KELLER ADD

Re: B16000366: proposal for addition – Waiver of Percolation Certification Plan

RE: B16000366; proposal for construction of addition at 4487 Wharff Lane

RE: B16000366; proposal for construction of addition at 4487 Wharff Lane

1st + 2nd Floor Planks:
Notes:
All dimensions to face
snipe put planks as
required per code
with joints shown as
above.

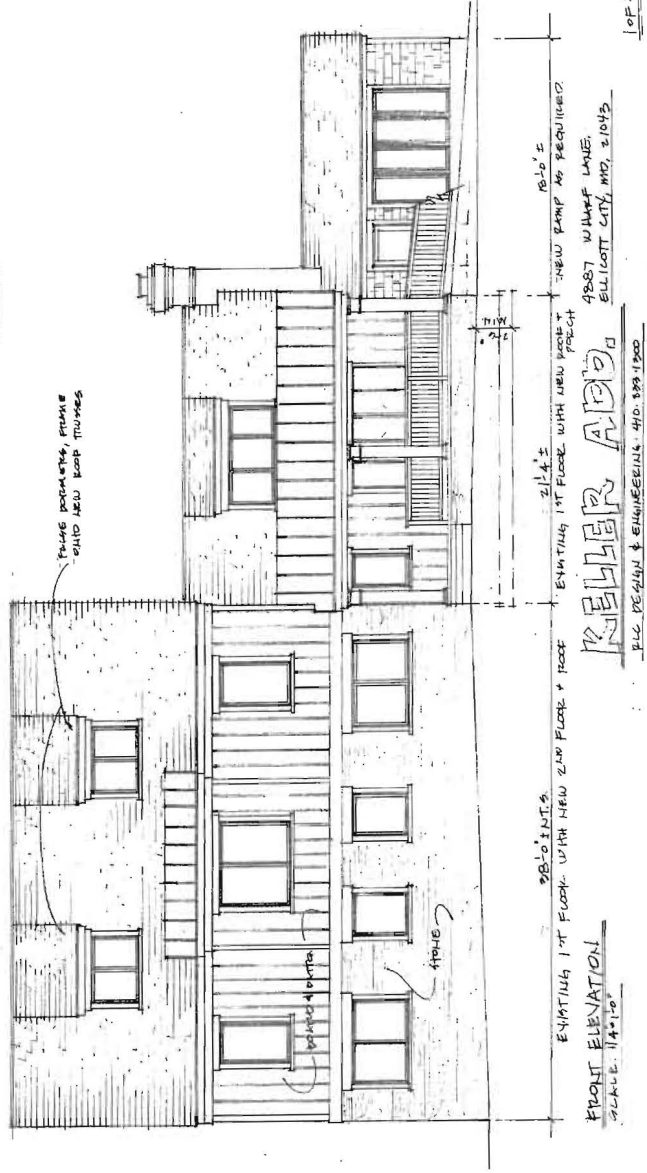
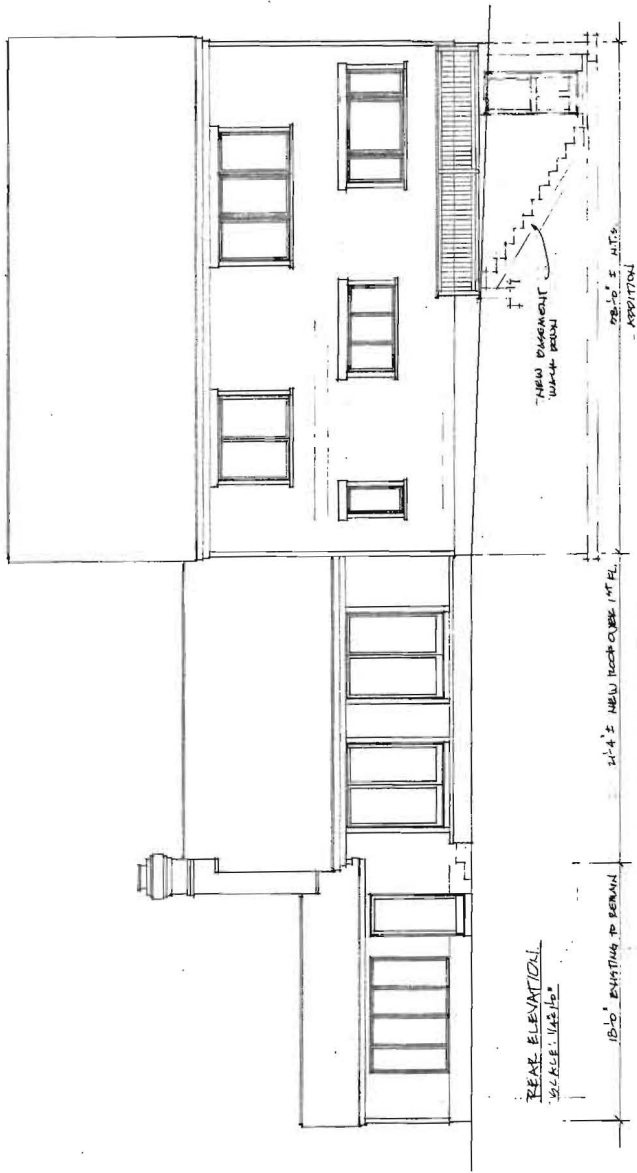
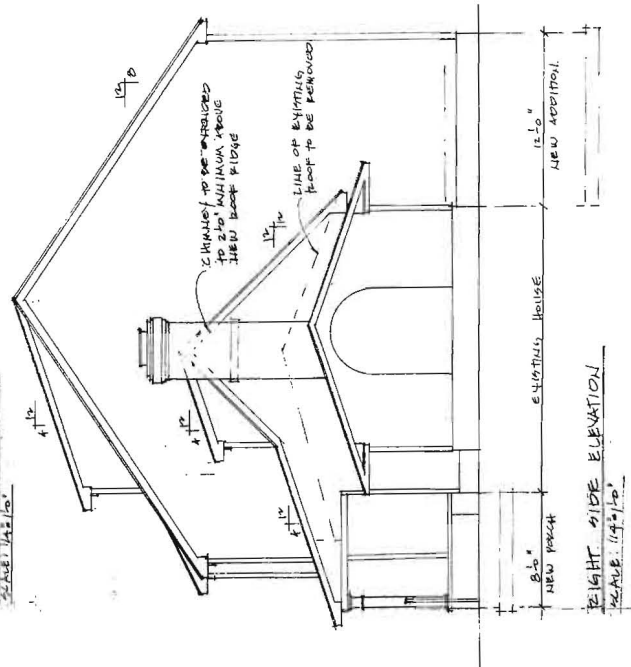
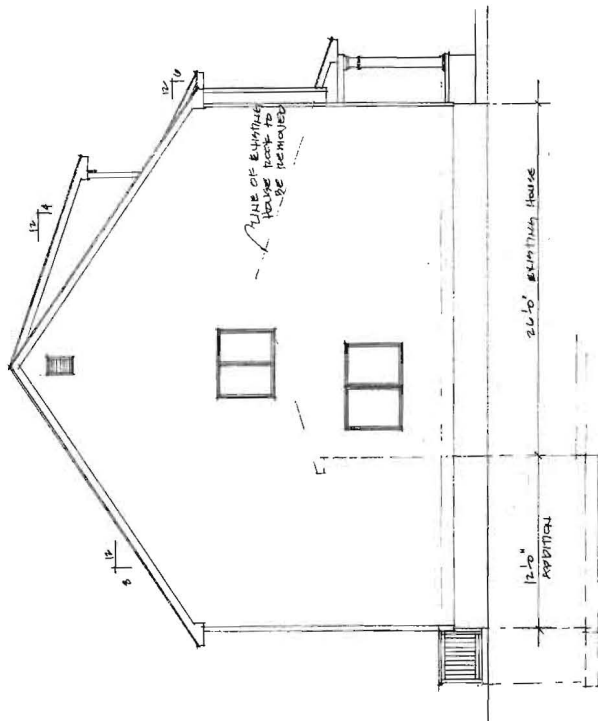
4. The floor plan includes a room (labeled as 'Playroom') that is greater than 90 sq.ft., and has a door, a closet, and a window. This room fits the Howard County Code definition of a bedroom [3.801(B)]. Construction of the room as proposed will cause an increase in the estimated daily peak wastewater flow for the residence, a condition which triggers the requirement for a septic system upgrade to include a Best Available Technology (BAT) unit and possibly additional trench absorption area.

- a. The 'Playroom' configuration may be modified. The revised floor plan must be submitted to DILP as a formal revision required by the Health Department.

- b. So as not to fit the Code definition of a bedroom, a redesign of the 'Playroom' would eliminate the 'closet (re: storage) and incorporate one of these three options:

- i. Eliminate the door and make the entrance to the room 4-feet wide,

- ii. Construct a half-wall between the 'Playroom' and another room,
OR
- iii. Encumber all walls in the 'Playroom' with built-in components
such as shelving and cabinets

I spoke with the the guy that did the well abandonment and he will send me a well abandonment certificate that I will forward to you. Also, I have attached an updated House Plan showing the 2nd fl office with clearly marked shelving and cabinets on all walls. Let me know if you need anything else.

3. A revision of the 2nd Floor (Upper Level) floor plan illustrating that the "Office" has no closet and the walls of the described space will be encumbered by built-in shelving and cabinets. This revision, received by email on April 14, illustrates a design for a three-bedroom residence, and is approvable when submitted to DILP as a formal revision.
